Project	IEEE 802.16 Broadband Wireless Access Working Group < http://ieee802.org/16 >	
Title	A frame structure for transparent relay and non-transparent relay coexistence mode	
Date Submitted	2007-4-10	
Source(s)	YuQiuxing, LiuQiaoyan, ZhaoLu	yu.qiuxingxa@zte.com.cn
	ZTE Corporation	liu.qiaoyanxa@zte.com.cn
		zhao.lu@zte.com.cn
Re:	IEEE 802.16j-07/007r2:“Call for Technical Comments and Contributions regarding IEEE Project 802.16j”	
Abstract	This contribution proposes a frame structure for transparent relay and non-transparent relay coexistence mode in IEEE 802.16j MR network.	
Purpose	Propose the text regarding frame structure design for transparent relay and non-transparent relay coexistence mode.	
Notice	This document has been prepared to assist IEEE 802.16. It is offered as a basis for discussion and is not binding on the contributing individual(s) or organization(s). The material in this document is subject to change in form and content after further study. The contributor(s) reserve(s) the right to add, amend or withdraw material contained herein.

A frame structure for transparent relay and non-transparent relay coexistence mode

Figure 2 frame structure of a transparent relay and non-transparent relay coexistence mode

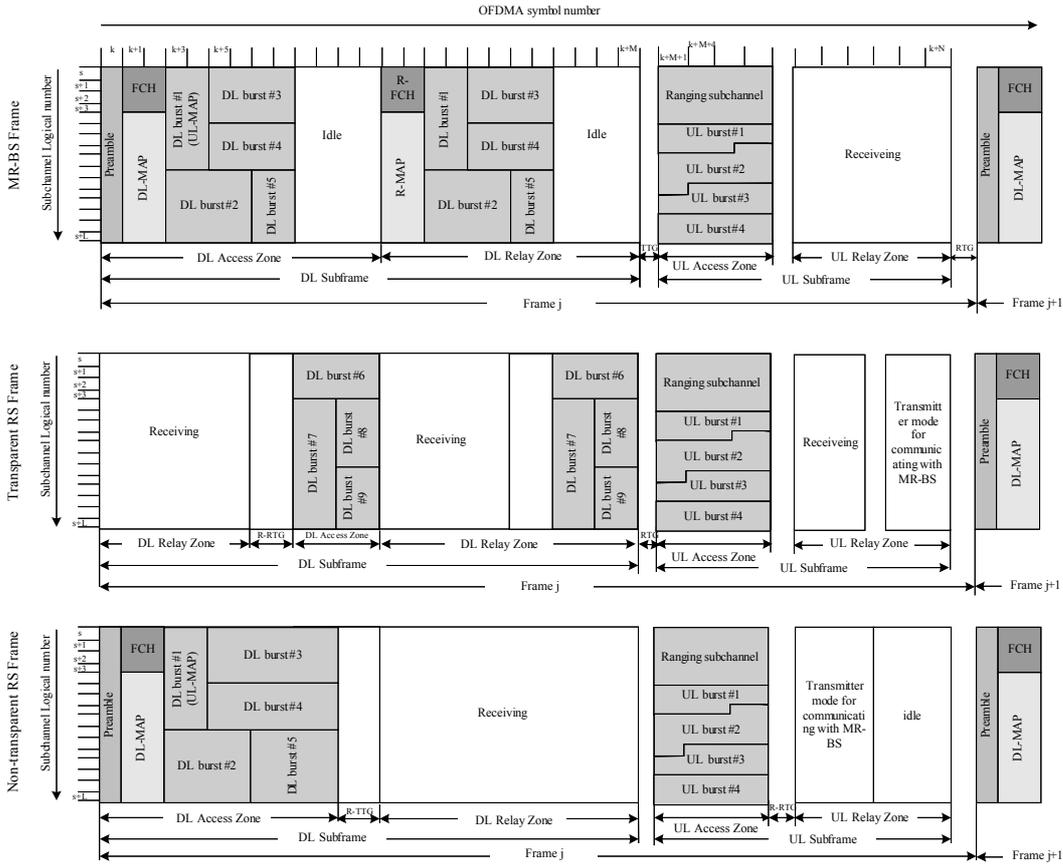
The TDD frame structure for a transparent relay and non-transparent relay coexistence mode illustrated in Figure 1 is proposed, as shown in Figure 2.

This proposed solution has following advantages:

- Diversity gain can be obtained because MR-BS and transparent RS transmit same information.
- Coverage can be extended because received signal quality in non-transparent RS is improved.
- Enhance the network reliability.

[Insert section 8.4.4.7.3 “Frame structure for transparent and non-transparent coexistence mode” as indicated:]

8.4.4.7.3 Frame structure for transparent and non-transparent coexistence mode

The frame structure consists of DL sub-frame period and UL sub-frame period. Each frame in the downlink starts with a preamble followed by an FCH, DL MAP and possibly UL MAP. The DL sub-frame shall include at least one DL Access Zone and one or more DL Relay Zone. The DL Relay Zones shall include an R-FCH, a DL R-MAP and possibly UL R-MAP. The UL sub-frame shall include one or more UL Access Zone and may include one or more UL Relay Zone. An Access Zone or Relay Zone here may be used for transmission, reception, or idle mode. In each frame, the TTG shall be inserted between the DL sub-frame and UL sub-frame. The RTG shall be inserted at the end of each frame.

For a transparent RS, the preamble and MAP are not transmitted at the beginning of the frame. Instead it listens to the preamble, DL MAP and possibly UL MAP from MR-BS. The detailed allocation for transparent RS can be indicated by MAP or R-MAP. The signaling method shall be negotiated in transparent RS network entry procedure. The TTG shall be inserted between the DL sub-frame and UL sub-frame. The RTG shall be inserted at the end of each frame.

The frame structure for transparent RS consists of DL sub-frame period and UL sub-frame period. The DL sub-frame shall include three zones. The first zone is used for transparent RS and MR-BS's subordinate MSs to receive bursts from the MR-BS, the second zone for transparent RS to transmit bursts to its subordinate MSs, and the last one for transparent RS to receive bursts from MR-BS and then send bursts to non-transparent RS. The UL sub-frame shall include zero or one zone for receiving bursts from its subordinate MSs, and zero or one zone for firstly receiving bursts from non-transparent RS and then transmitting bursts to MR-BS. The R-TTG or R-RTG shall be inserted between transmission and reception mode in DL sub-frame and UL sub-frame.

The frame structure for non-transparent RS consists of DL sub-frame period and UL sub-frame period. The DL sub-frame shall include at least one DL Access Zone and one DL Relay Zone. DL Access Zone begins with a preamble followed by DL MAP and possibly UL MAP. DL Relay Zone is utilized for reception from MR-BS and/or transparent RS. The UL sub-frame shall include at least one UL Access Zone and one UL Relay Zone. UL Relay Zone is divided into two intervals. One interval is used for transmission to MR-BS and the other for idle mode. The R-TTG or R-RTG shall be inserted between transmission and reception mode in DL sub-frame and UL sub-frame.
